Re: CPO: Blanchardstown Bus Corridor, Case Reference: KA29N.313961

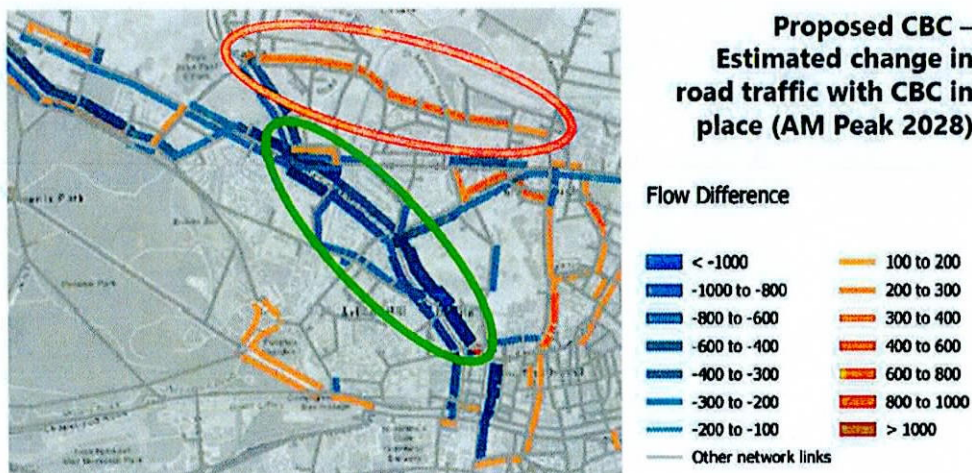
There are three road restriction changes proposed in the CPO application for the Blanchardstown Bus Corridor, none of which were set out in any of the proposed designs issued for public consultation since the Bus Connects project commenced in 2018.

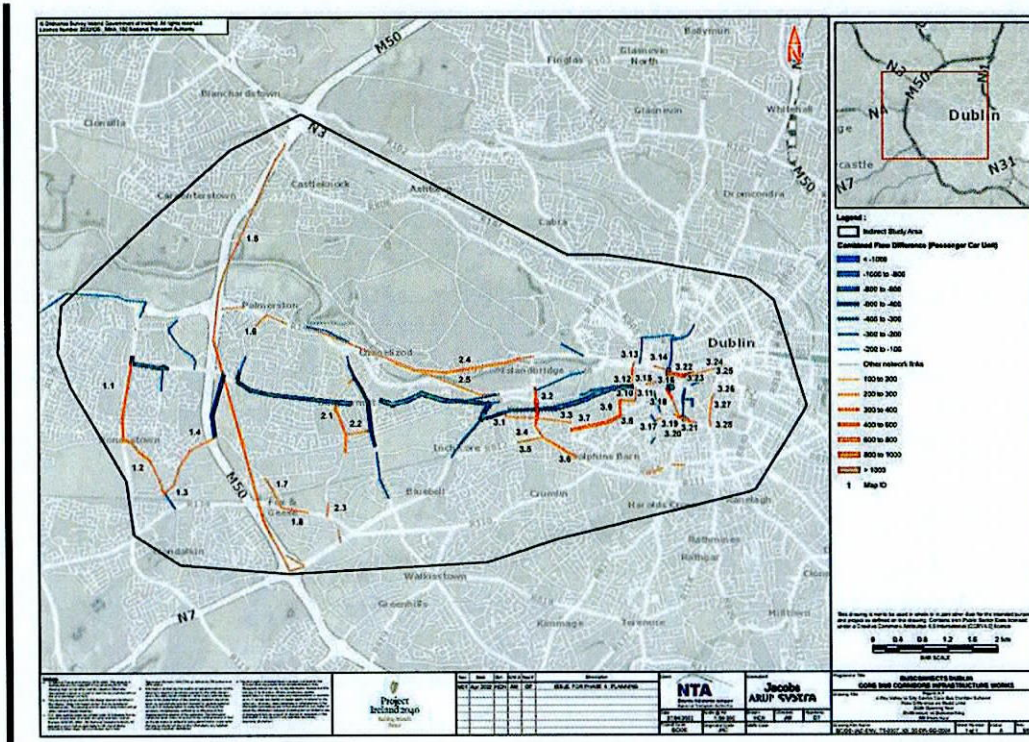
- An 80% increase in hourly traffic flows at the junction of Connaught Street and Shandon Crescent,
- A 55% increase in hourly traffic flows at the junction of Fassaugh Ave and Dingle Road,
- A 64% increase in hourly traffic flows at the junction of Fassaugh Ave and Bannow Road.

Each is described as having “not significant” effect and “negligible” impact. I can tell you as a resident of Connaught Street there is no way that changes of this nature can be considered “not significant” and “negligible” in their impacts on our abilities to go about our daily lives and live in a safe environment!
